REGIONAL REVIEW NOTIFICATION

Name of Proposal: Forge Atlanta DRI 3533
Submitting Local Government: City of Atlanta

<u>Description</u>: A DRI review of a proposal to construct a large-scale mixed-use development in the southwest area of downtown Atlanta on a 10-acre site bounded by Packard Street on the north, Ted Turner Drive on the east, Whitehall Street on the southeast, and the Central of Georgia rail line. The project proposes 1,500 multi-family residential units, a 260-room hotel and conference center, 50,000 SF of cultural activity space, 1,750,000 SF of office space, and 69,000 SF of retail space in seven 20 to 30 story buildings. Vehicular access is planned via 5 driveways, one on Packard Street, one on Ted Turner Drive, and three on Whitehall Street. The project is within a quarter mile of the Garnett MARTA station and multiple transit bus stops. Associated sidewalk and bicycle improvements are planned.

DRI SITE PLAN - 2 GRAPHIC SCALE IN FEET SHEET NUMBER DRI #3533

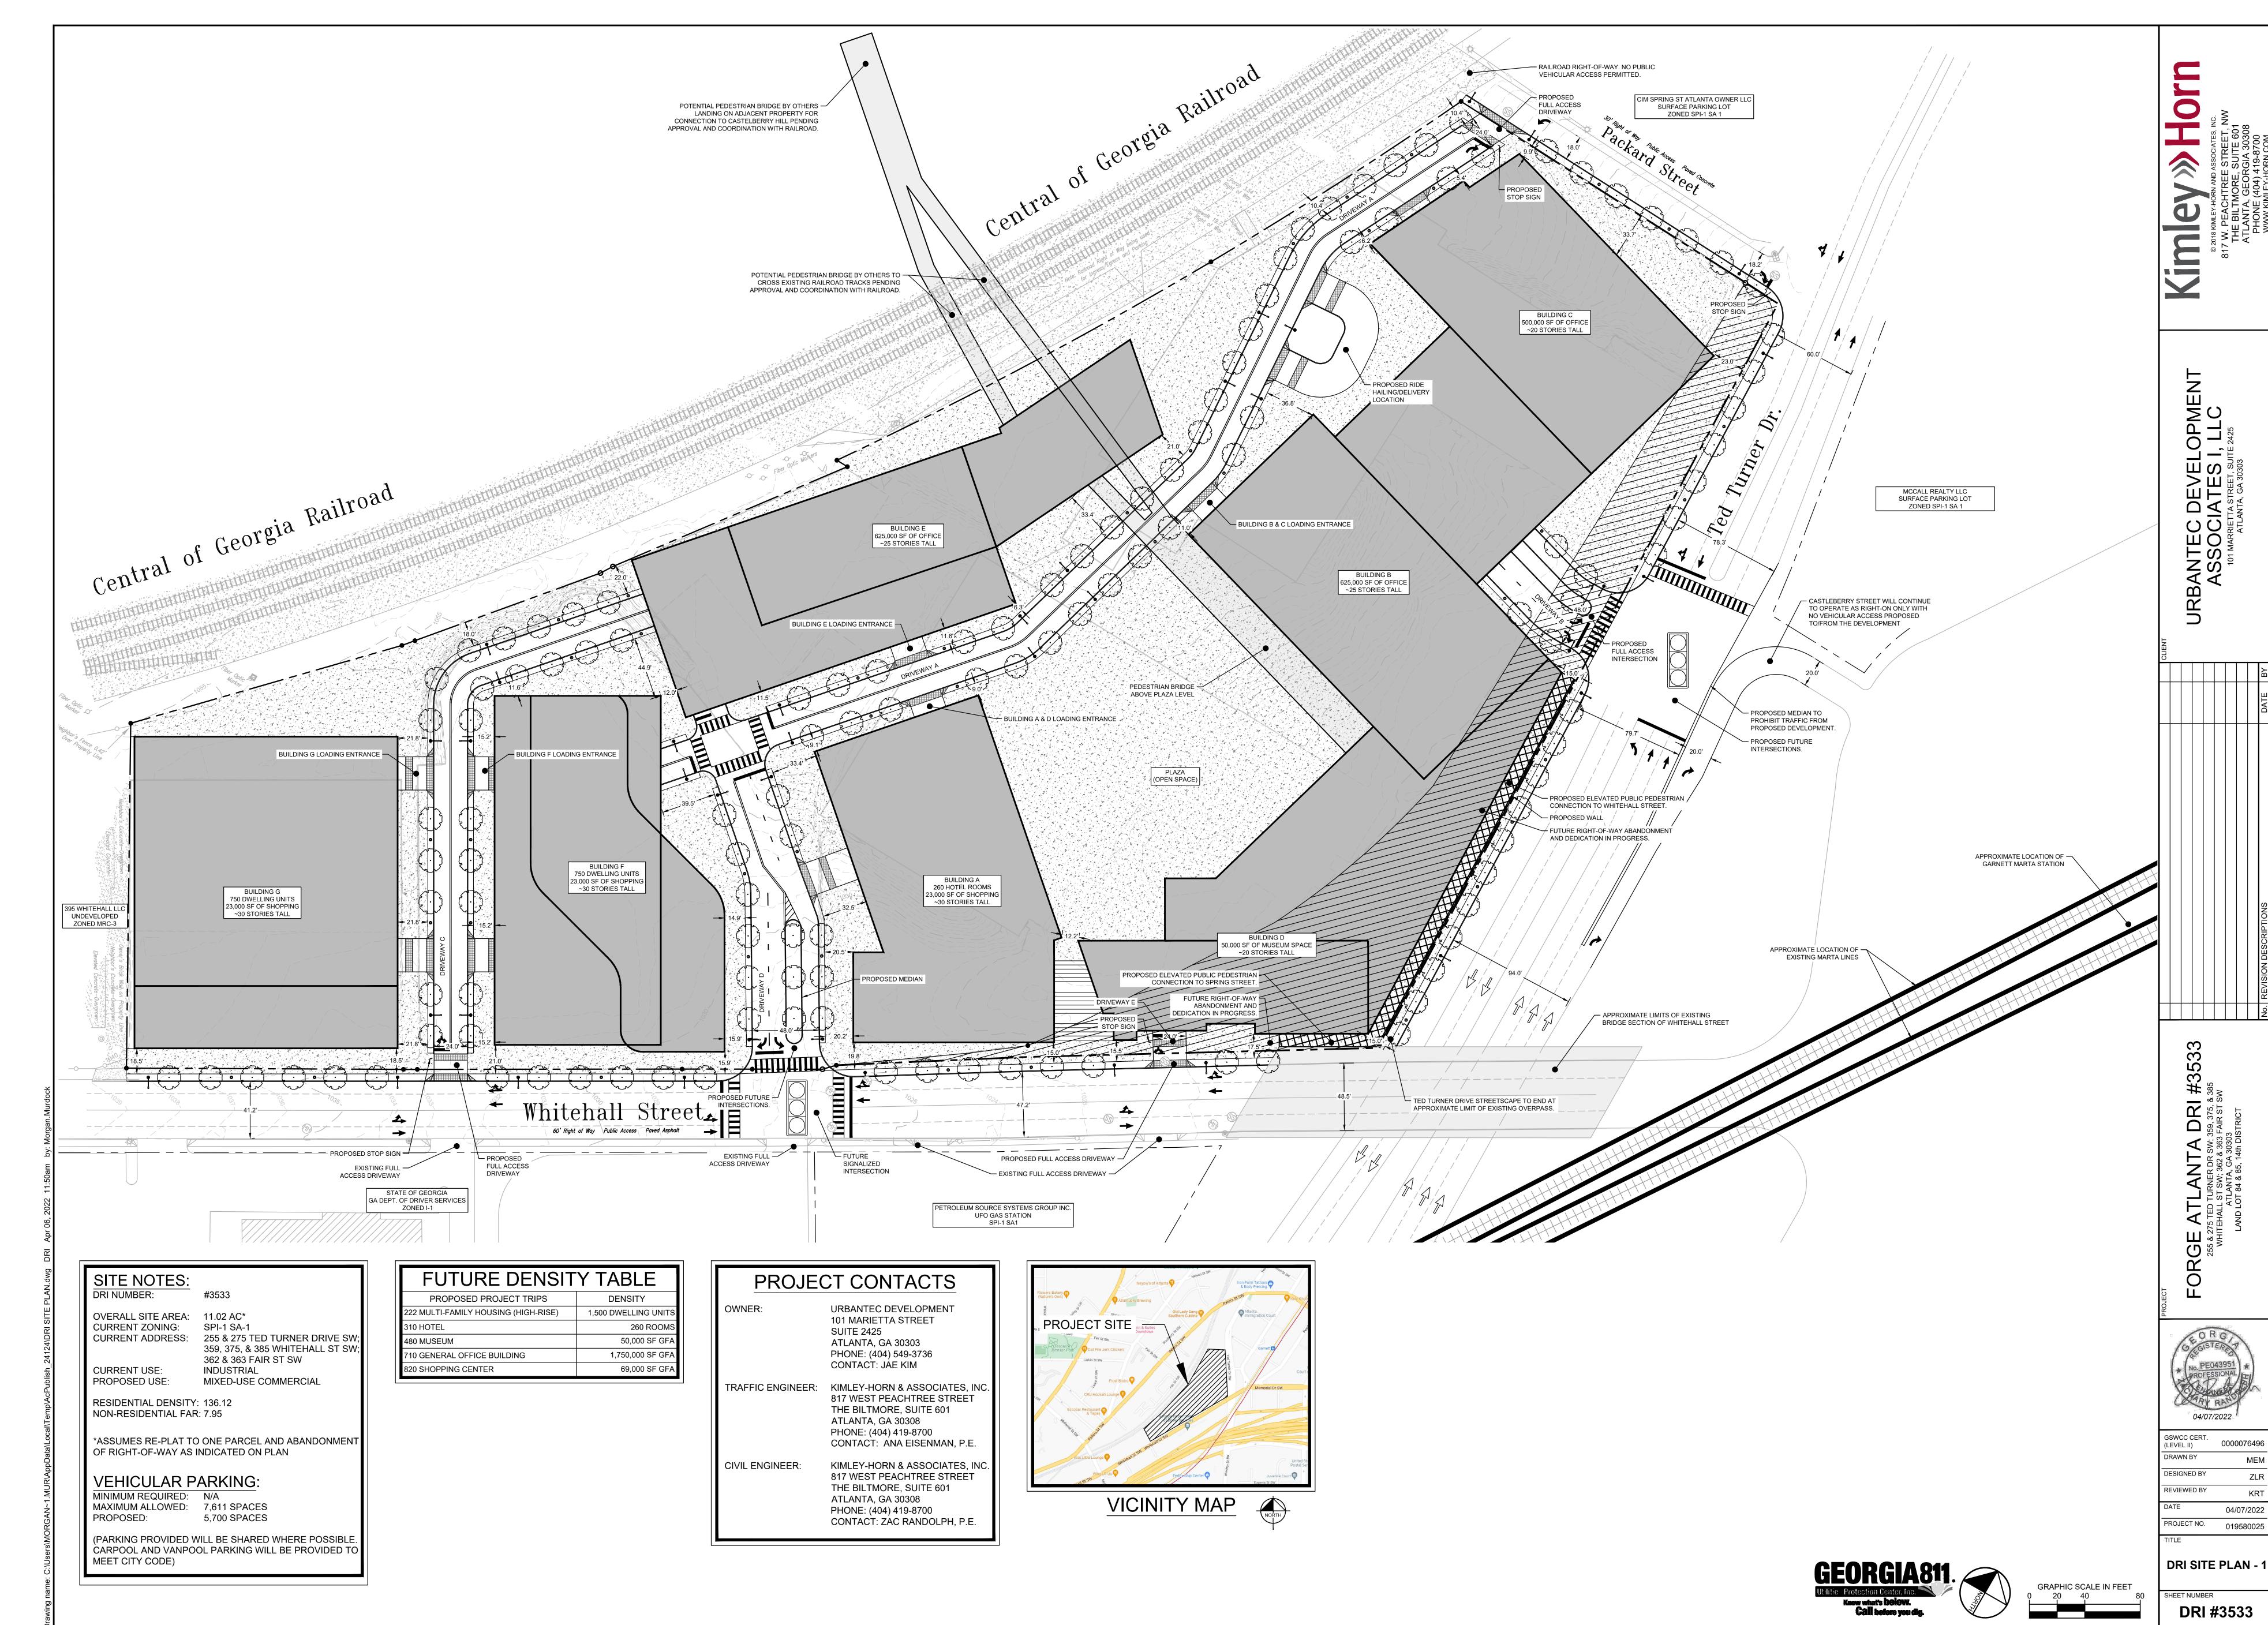
Approximately 5,700 parking spaces are proposed of which between 375 and 675 would be EV charging spaces; reducing the total number of parking spaces and maximizing EV charging spaces would advance regional transportation and sustainability policies.

A more robust and holistic approach to creating welcoming and safe sidewalk and bicycle connections to the project, particularly along the route to the Garnett MARTA station, would advance regional sustainability and multi-modal transportation policies and goals.

The project is expected to generate a total of 18,807 daily new car trips and 8,193 transit, sidewalk, and bicycle trips. Roadway and sidewalk/bike lane improvements are proposed to accommodate these trips. The sidewalk improvements consist of scattered repairs and infill of missing segments and crosswalks. A more robust holistic approach to creating continuous safe and inviting new sidewalk routes would better serve the achievement of walkability and transit use goals. The short one-way and barely used quarter block of Castleberry Street offers an opportunity to create a wide pedestrian portal to the project along the critical route between the Garnett station and the project.

The three driveways proposed on Whitehall Street are fairly close together and will disrupt the bike and pedestrian flow in that location. A reduction to two driveways would be supportive of creating a safer and more inviting biking and walking environment.

A total of 5,700 structured parking spaces are proposed; reducing the total number of parking spaces would advance regional transportation and sustainability policies.

A total of 50 bicycle parking spaces and 4 showers are proposed. Additional bicycle parking spaces and shower facilities would strengthen the project's multi-modal transportation and sustainability approach.

Care should be taken to ensure that the constructed development provides an interconnected, functional, clearly marked and comfortable pedestrian experience on all driveways, paths, entrances, and parking areas. To the maximum extent possible, new driveways and intersection corners where pedestrians will cross should be constructed with minimal curb radii to reduce speeds of turning vehicles and decrease crossing distances for pedestrians.

The project can further support The Atlanta Region's Plan by incorporating other aspects of regional environmental policy, including green infrastructure and/or low-impact design, e.g., pervious pavers, rain gardens, vegetated swales, etc., in parking areas and site driveways, and as part of any improvements to site frontages.

Between 375 and 675 EV charging spaces are proposed; Inclusion of additional EV charging stations would be supportive of regional EV infrastructure development plans.
